Commonwealth Edison

Subject: Byron Station Units 1 and 2
Braidwood Station Units 1 and 2
Control Room PDA
NRC Docket Nos. 50-454/455 and 50-456/457

References (a) and (b) provided the Byron and Braidwood Station Control Room Preliminary Design Assessment (PDA) along with Supplements I and II in response to NUREG 0660 Task Action Plan Item I.D.1 and Section 18 of the Byron Station SER. The purpose of this letter is to provide revisions to certain Human Engineering Deficiencies (HEDs) contained in Reference (b) that should allow for closure of Outstanding Item No. 17 in the Byron Station SSER No. 3.

1.2

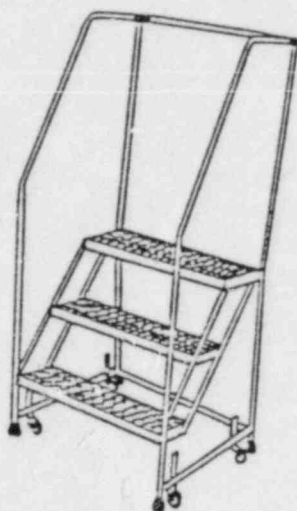
Some of the controls on the stand-up console are located out of reach of the 5% height operator. The highest control is located 65" from the floor (recommended maximum = 60").

CE Response: Several controls on 1PM04J (Feedwater Panel) are located 65" from the floor. These controls are separated into four groups with three controls (Steam Flow, Feed Flow, and Steam Generator Level) included in each group. The purpose of these controls is to select the controlling channel for the Steam Flow, Feed Flow, and Steam Generator Level parameters. The controls are used with an estimated frequency of two times a year (in addition to four times per year for calibration). These controls are not used during an accident scenario and are therefore not time-critical. They are only used to change to an operable channel after the system has been stabilized.

A step ladder will be available, as a temporary solution, to aid the fifth percentile female in reaching the switches. This will also be equipped with handrails, as shown below, to prevent falls and to prevent inadvertent actuation of controls. These controls will be reviewed along with other board changes based on the conduct of a DCRDR.

3.6

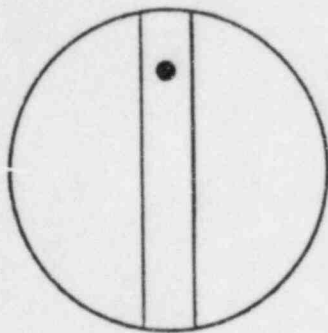
A manually initiated annunciator block is available for Feedwater, Condensate and Turbine Control panels. Two red alternating flashing lights indicate when the block is in use. The annunciator silence buttons silence only a single audible alarm, whereas the guidelines state that it should be possible to silence an auditory alert signal from any set of annunciator response controls in the primary operating area.

CE Response: Any of the annunciator response controls in the primary operating area will silence all of the horns in the area.

A manually initiated timed audio block is available for the Condensate and Turbine panels. The audio block must be manually initiated by the operator when permitted by the condition that one of four throttle valves on the main turbine is closed. A time delay relay (which has a range of 0 to 30 minutes) is energized, which de-energizes a green light marked RESET and energizes a red light marked BLOCK and inhibits the turbine associated audible alarms from (2) 1UL-ANO25 and (2) 1UL-ANO26 on panels (2) 1PM02J and (2) 1PM03J respectively. The time delay relay has initially been set for 10 minutes. A manual reset function (on the same switch) is provided to permit the operator to reset the audio block any time after its actuation and before it has timed out to automatically reset.

When reset occurs by the time delay relay having timed out or by operator action, the red light indicating BLOCK is de-energized and the green light which indicates RESET is energized and the annunciator block is removed.

4.12

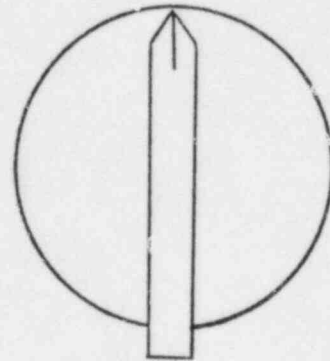
On 1PM06J, the same type of control handles are used for valves with different functions. An operator cannot differentiate among throttle, open/close and throttle open-seal close valves. (4.4.19) (2.3.3.1-9)

CE Response: Throttle valves will be supplied with a non-lever type handle. All other valves will have lever type handles. There are no throttle open-seal close valves. The lever and non-lever type handles are shown below.
